APPLICATION SUPPLEMENT

Application for a Performance-Based, Multi-Site Radioactive Materials License to Operate a High-Pressure Slurry Ablation Remediation System

Docket Number: 40-38417

**Issuing Agency:
U.S. Nuclear Regulatory Commission**

Figure 14-1: MILDOS Source and Receptor Locations (Application Figure 7-3)

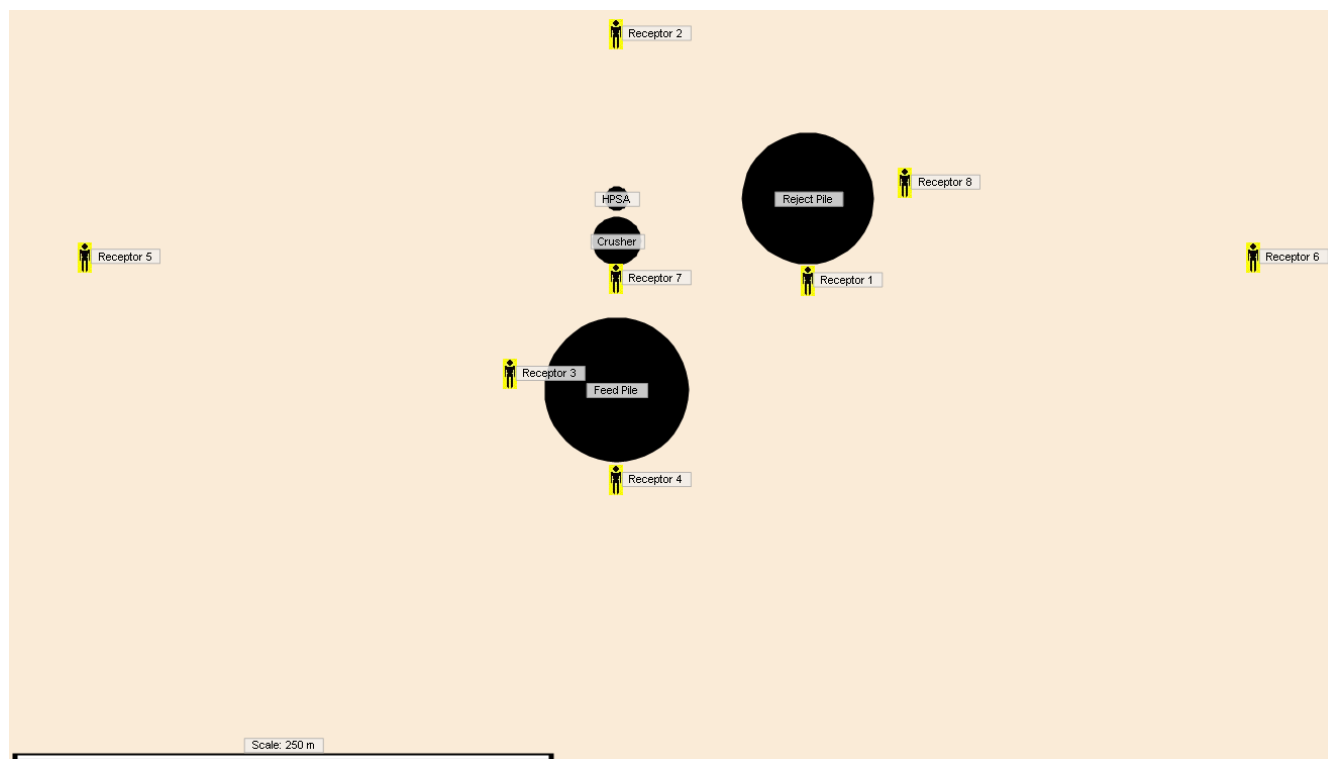
DISA updated, the MILDOS model for internal dose estimates during operations address NRC staff questions. Receptors representing public doses were moved closer to the operations to be consistent with conservative restricted area boundaries. Assumptions for external dose models assumed restricted area boundaries were 50 feet (15.2 meters) from operations (i.e., members of the public cannot access operational areas closer than 50 feet). The MILDOS model is now consistent with this assumed restricted area boundary (Affected receptors are #1, 3, 4, and 8).

The internal dose model results reported in the license application (Section 7.3) conservatively assumed an occupancy factor of 1. It did not assume the same occupancy (1/40 or 1/20) as the external dose models. To increase consistency and provide more representative results, the agreed upon occupancy factors (1/4 for occupational, 1/20 for public) have been included in this updated analysis. Therefore, the results indicate more representative receptor locations and occupancy factors. Updated application report tables and figures are included here.

Receptor	Receptor Type	Total Annual Dose (mrem)
1*	Public	0.4
2	Public	0.1
3*	Public	0.4
4*	Public	0.5
5	Public	< 0.1
6	Public	< 0.1
7	Occupational	5.6
8*	Public	0.4

* Indicates updated receptor location to be located 50 feet from edge of source term.
